Access Compliance Report

Public Rights-of-Way

| Intersection ID: 50867 | Main Street: REAMES_RD | Cross Street: BROOKLINE_RIDGE_DR | Location: S |
| ADA ID: 48BEEBE95A25 | Ramp Type: Perp | Initial Pass/Fail: Fail | Overall Compliance: No |

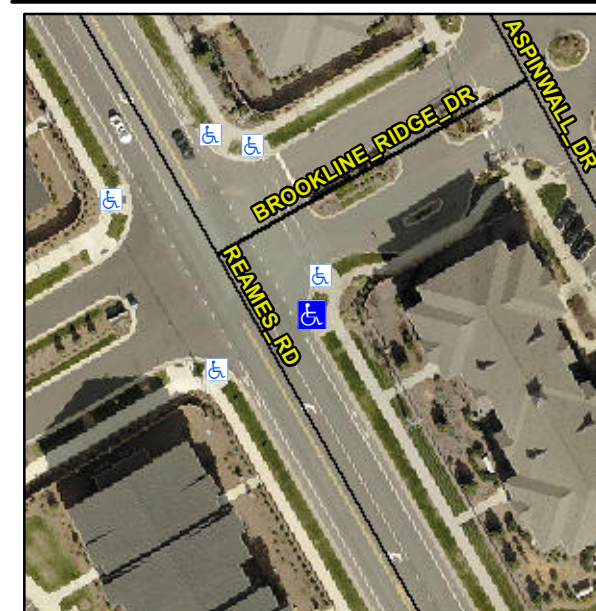
Not Found, R304.5.1

| Compliance | Description | Data | Compliance | Description | Data |
|------------|-----------------------|------|------------|-----------------------------|------|
| No | Ramp Width (in) | 47.0 | Yes | Ramp XSlope (%) | 1.5 |

Remove & Replace Entire Ramp.
